# UNITED STATES PATENT AND TRADEMARK OFFICE

APPLICATION NO.	FILING DATE	FIRST NAMED INVENTOR	ATTORNEY DOCKET NO.	CONFIRMATION NO.
09/733,104	12/07/2000	Steven Teig	SPLX.P0004	2615
23349	7590	10/27/2003	EXAMINER	
STATTLER JOHANSEN & ADELI P O BOX 51860 PALO ALTO, CA 94303			CHU, CHRIS C	
			ART UNIT	PAPER NUMBER
			2815

# Office Action Summary

## **DETAILED ACTION**

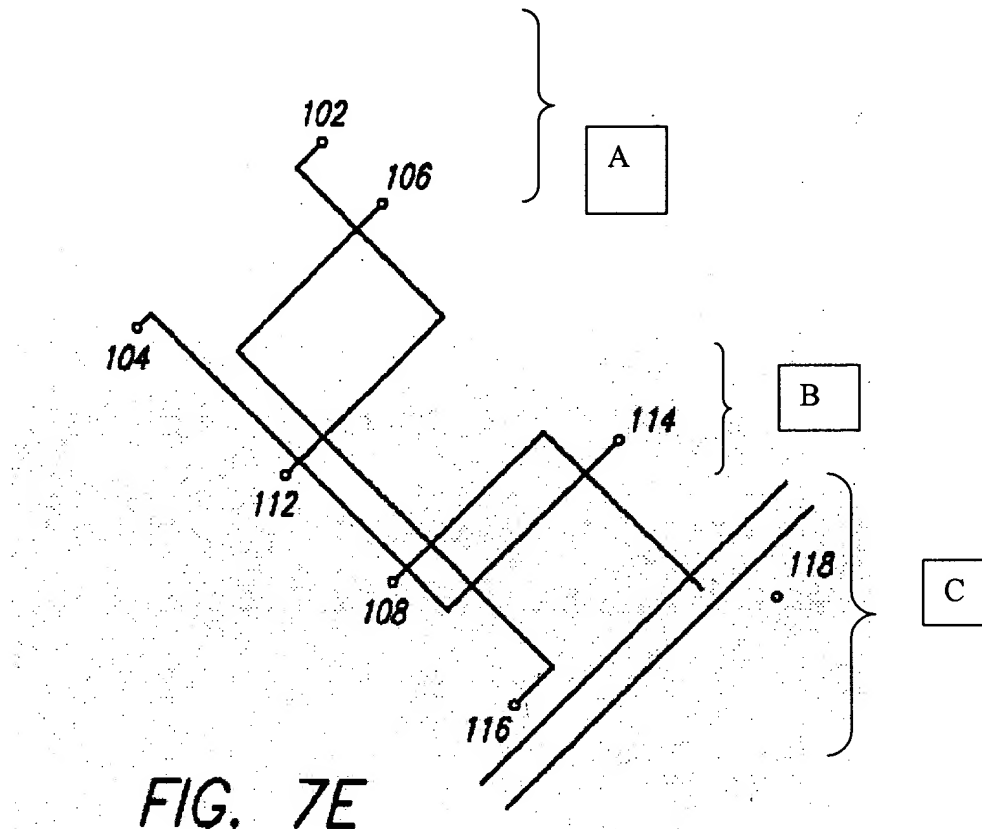
Applicant argues “applicants respectfully submit that the drawings do show both these features. For instance, Figure 10 illustrates a section 1010 of metal layer 1000 that includes a Manhattan line 1012 (in this case a horizontal line) connected to a conductor in the preferred diagonal direction of the section 1010. In addition, Figure 14 illustrates interconnected horizontal and diagonal wiring.” This argument is not persuasive. First, applicant does not clearly redefine the claim term “Manhattan or Manhattan wiring direction” in the rejected claims that the Manhattan or Manhattan wiring direction is a horizontal line direction. Second, applicant should note that the usual meaning of the term “Manhattan” is a rectangular or right-angle rectilinear.

Since Fig. 10 and Fig. 14 are not illustrated the rectangular or right-angle rectilinear line coupled to a conductor deposited in the preferred diagonal wiring direction, the objection to the drawings is maintained.

Applicant argues “applicants respectfully submit that the drawings do show both these features. For instance, Figure 10 illustrates a section 1010 of metal layer 1000 that includes a Manhattan line 1012 (in this case a horizontal line) connected to a conductor in the preferred diagonal direction of the section 1010. In addition, Figure 14 illustrates interconnected horizontal and diagonal wiring.” This argument is not persuasive. First, applicant does not clearly redefine the claim term “Manhattan or Manhattan wiring direction” in the rejected claims and set forth the uncommon definition so as to put one reasonably skilled in the art on notice that the applicant intended to so redefine that claim term that the Manhattan or Manhattan wiring direction is a horizontal or vertical line direction. Second, applicant should notes that the usual meaning of the term "Manhattan" is a rectangular or right angle rectilinear and a non rectangular or none right angle rectilinear is called “non-Manhattan”. The wiring in Fig. 10 and Fig. 14 are non-Manhattan wirings. Thus, Fig. 10 and Fig. 14 are not illustrated Manhattan wirings, that has rectangular or right angle rectilinear line, coupled to a conductor deposited in the preferred diagonal wiring direction, the rejection is maintained.
